RESPONSE TO REQUEST FOR ADDITIONAL INFORMATION

APR1400 Design Certification

Docket No. 52-046

RAI No.: 531-8715
SRP Section: 10.4.9 – Auxiliary Feedwater System (PWR)
Application Section: 10.04.09
Date of RAI Issue: 11/28/2016

Figure 10.4.9-1 Auxiliary Feedwater System Flow Diagram (1 of 3)

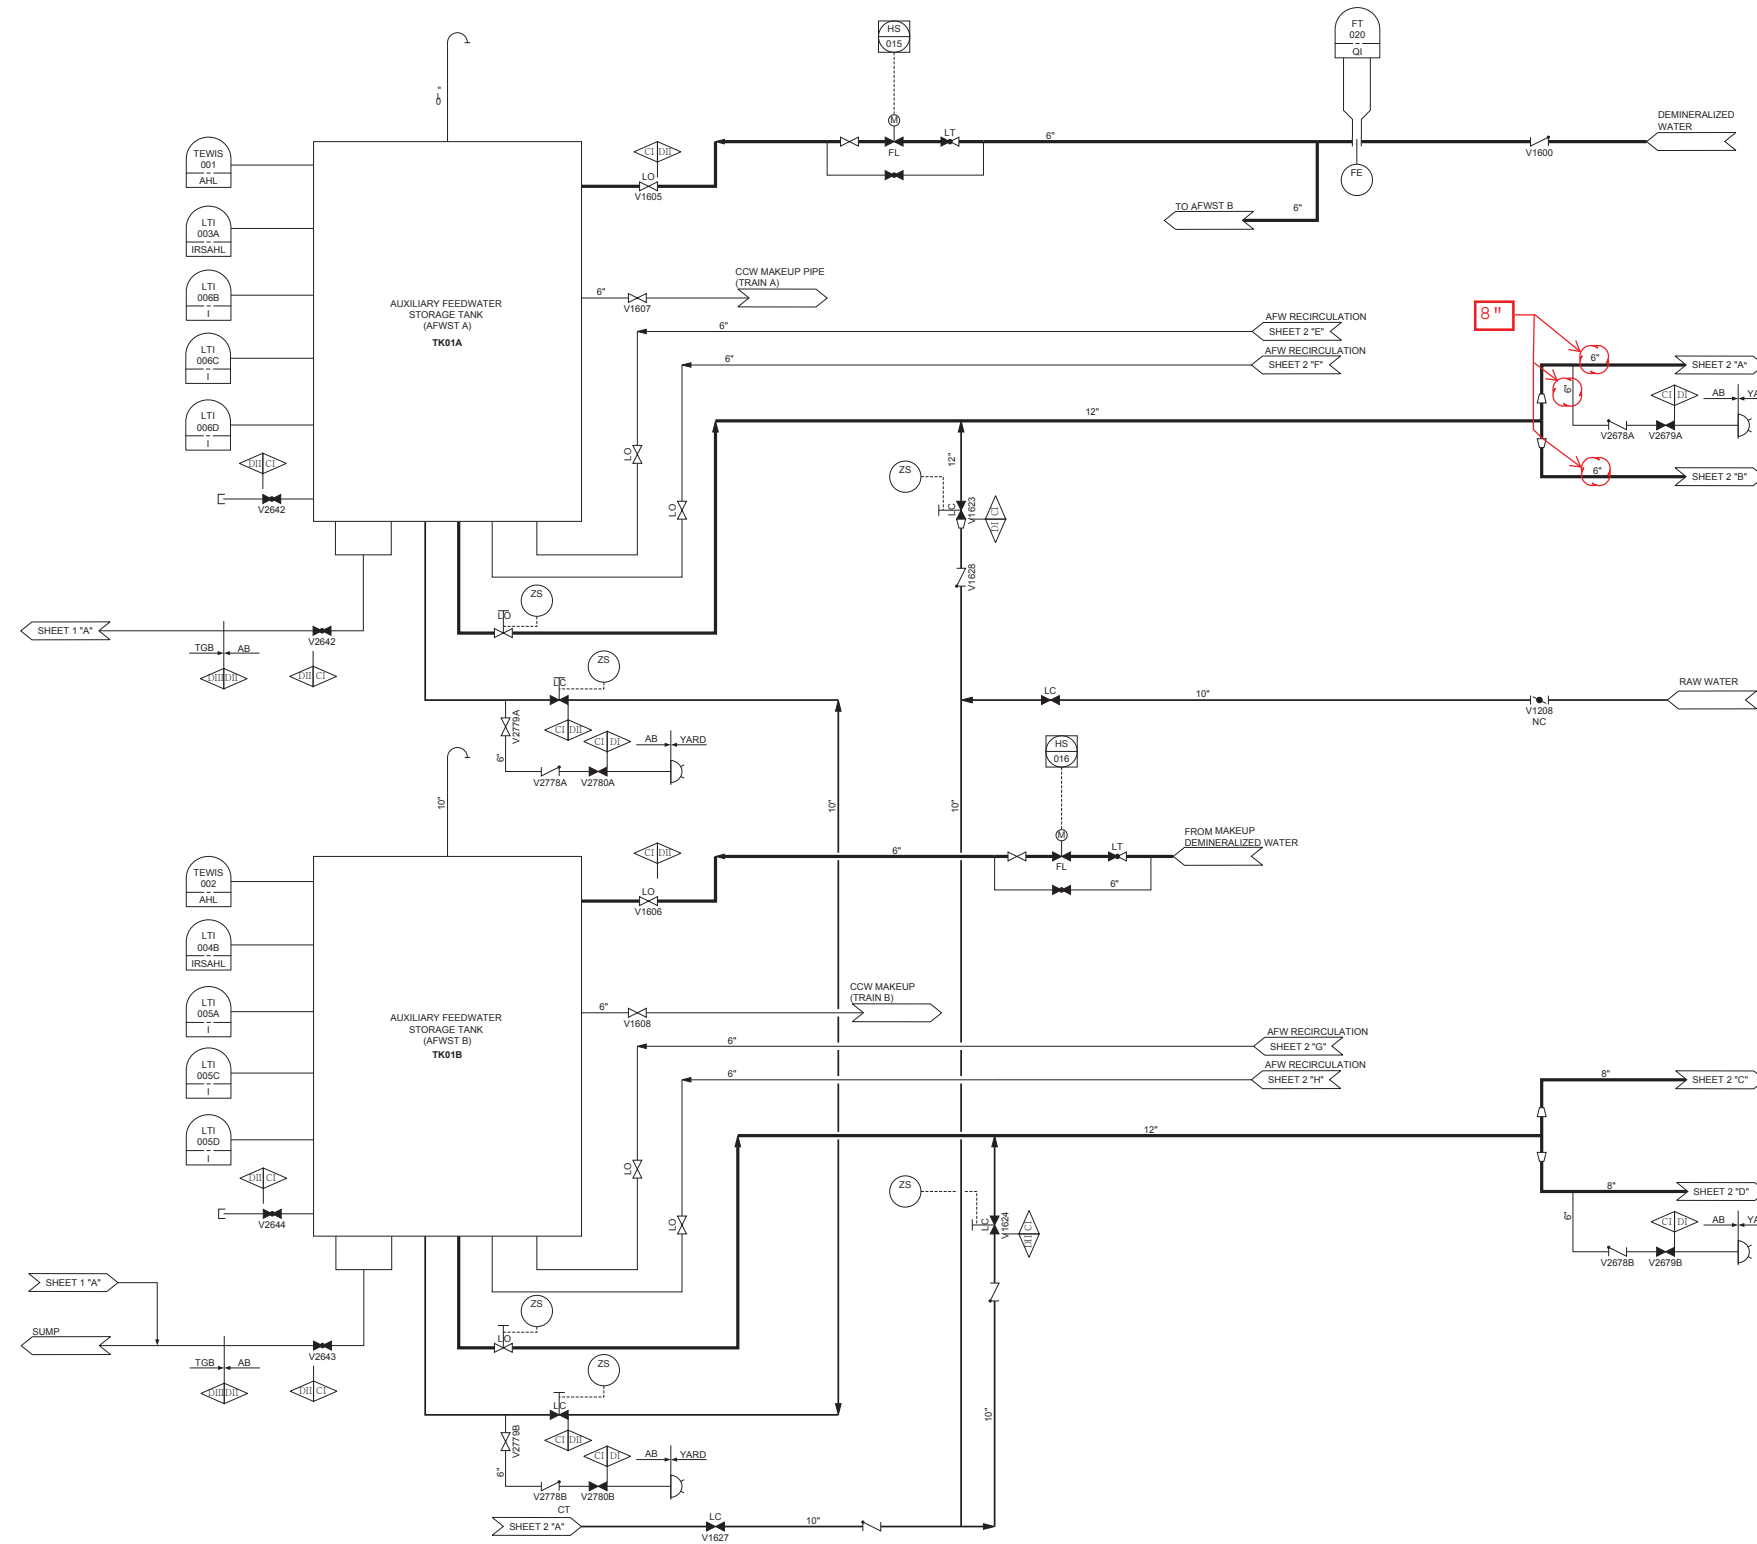
10 CFR 50.59(a) requires that information provided to the NRC by applicants for a license be complete and accurate in all material respects. The staff has found inconsistencies in the pipe size shown in DCD Figure 10.4.9-1 for the auxiliary feedwater pump suction lines. Specifically, the line leaving tanks TK10A and TK10B, on sheet 1 of Figure 10.4.9, are shown as 12 inches in diameter. The line from tank TK10A is divided into two 6-inch diameter lines which supply water to AFW pumps A and C. The line from tank TK10B is divided into two 8-inch diameter lines which supply water to AFW pumps B and D. These four suction lines (supplying water to pumps A through D) are shown on sheet 1 of Figure 10.4.9-1 and continued onto sheet 2 of Figure 10.4.9-1; however, on sheet 2, these 4 lines are shown as 10-inch diameter lines.

- (a) Reconcile the above noted discrepancies regarding the line size of the piping that supplies the AFW pumps with water from the AFWSTs and eliminate the inconsistencies in sheet 1 and 2 of Figure 10.4.9-1.
- (b) If the line sizes for the two AFW division are meant to be different, provide a discussion of why different line sizes are used for the different AFW divisions since the flow requirements for both divisions are the same, and provide the reason both line sizes are acceptable in the design.

There were editorial errors in figure 10.4.9-1(1 of 3 and 2 of 3). The auxiliary feedwater pump suction line size branched from 12 inch common line of each auxiliary feedwater storage tank, is 8 inch instead of 6 inch or 10 inch. The different line sizes on figure 10.4.9-1 (1 of 3 and 2 of 3) in the DCD will be revised from 6 inch and 10 inch to 8 inch.

DCD Tier 2, Figure 10.4.9-1(1 of 3 and 2 of 3) will be revised as indicated on the attached markup.
